Addendum

SPRINGS AT FREMAUX TOWN CENTER
SLIDELL, LA

FIRST FLOOR PLUMBING PLAN - CLUBHOUSE

P1.C.11

FOUNDATION PLUMBING PLAN - CLUBHOUSE
SCALE: 1/8" = 1'-0"

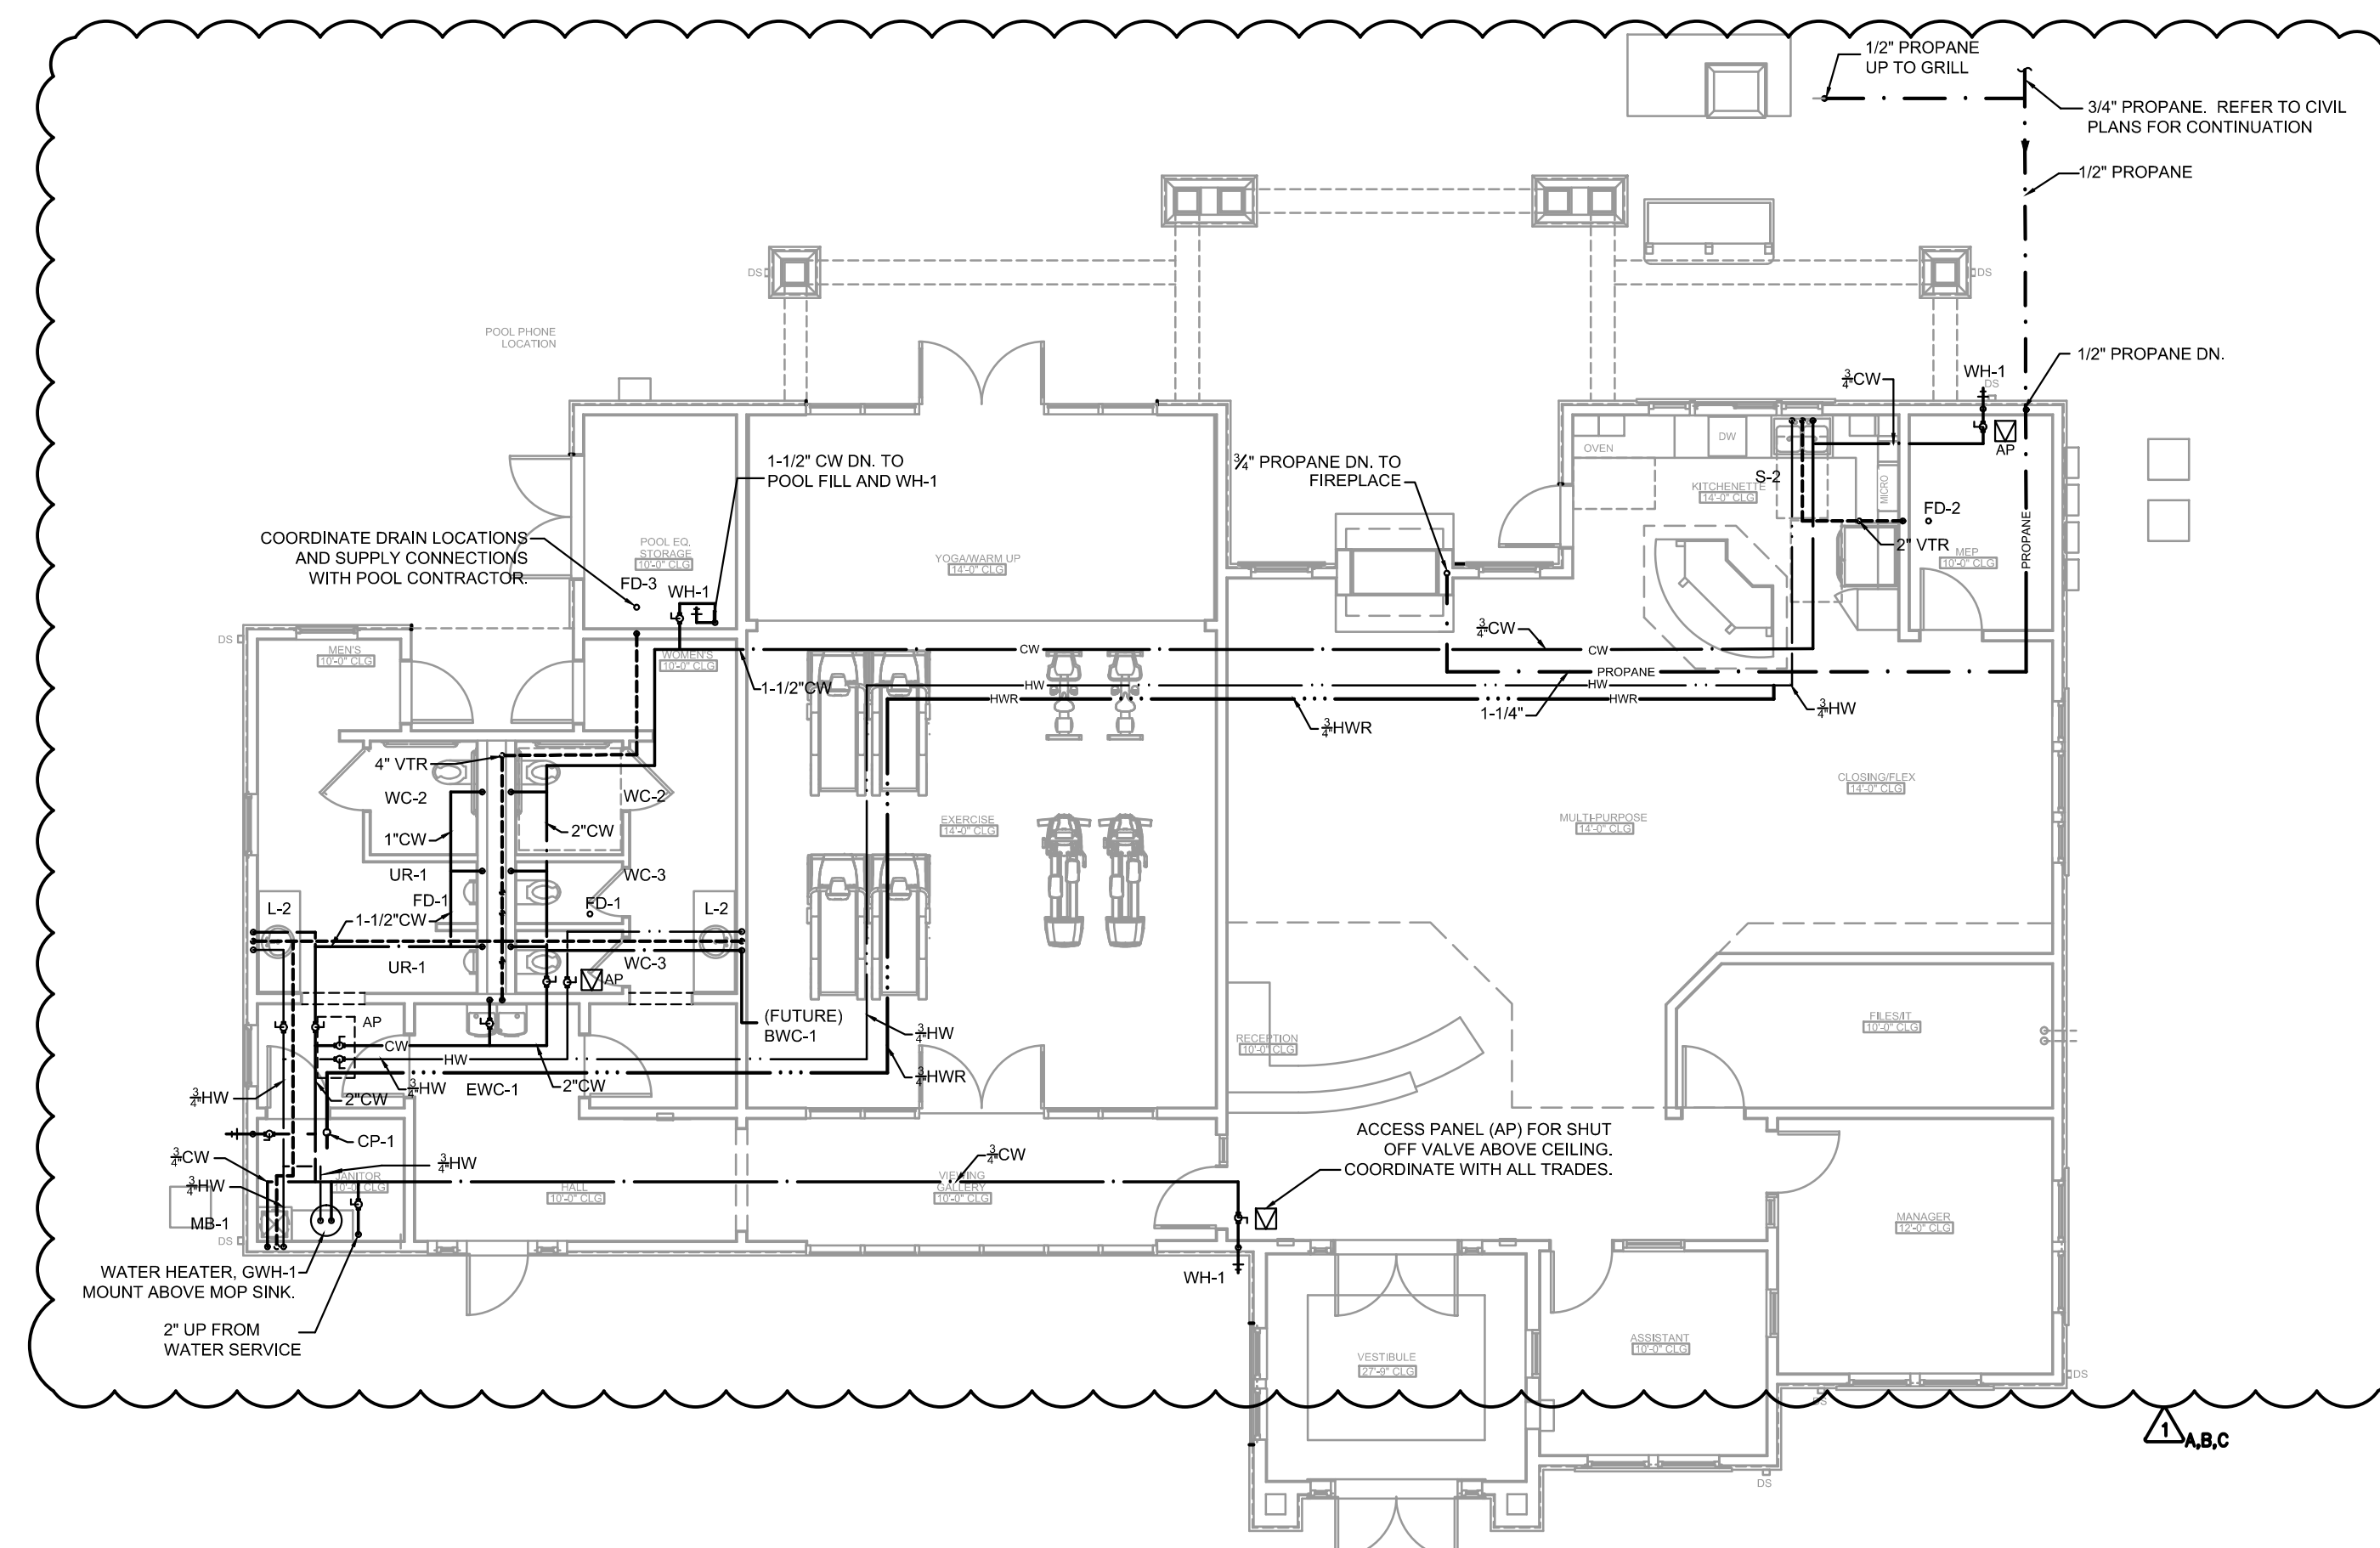
- A. REVISED GAS LINES FOR PROPANE
- B. REVISED PLUMBING PER REVISED BASE PLAN
- C. ADDED WATER LINE FOR FUTURE BOTTLELESS WATER COOLER
